Case #: ZBA 2012-73
Date: September 13, 2012
Recommendation: Unable to Recommend
Approval

UPDATED PLANNING STAFF REPORT¹

Site: 13 Elmwood Street

Legal Notice: Applicant, Franziska Amacher, and Owner, Chunga Cha, seek a Variance (SZO §5.5) in order to build a 1.5 foot extension of the first story of a porch into the front yard setback.

1.1' EXTENSION INTO 10'-0' SETBACK
 PROPOSED AVERAGE SETBACK = 112"
 ▨ = DECK

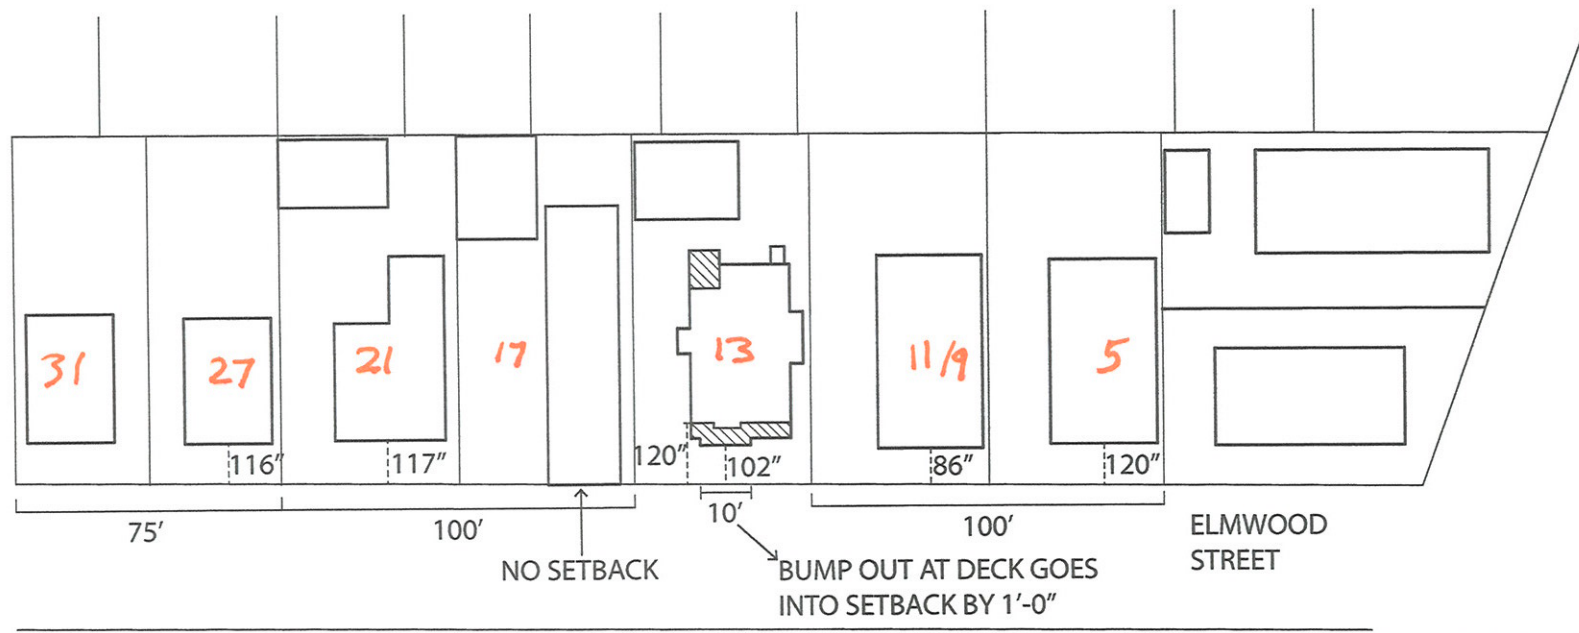
The Applicant stated, “In order to fit with the porches on adjacent house fronts, we are installing a deck. At the existing bay window the depth of the deck is only 2’-0”. We propose to extend the deck only around the first floor bay window by one foot into the 10’-0” setback. Everywhere else the setback will be conforming to the 10’-0” required. Note that adjacent houses have setbacks ranging from zero, 7’-2”, 9’-8” to 9’-9”.”

The Applicant stated, “This small 1’-0” projection into the setback will be only at the first floor, and it will fit behind the average setback of adjoining houses.”
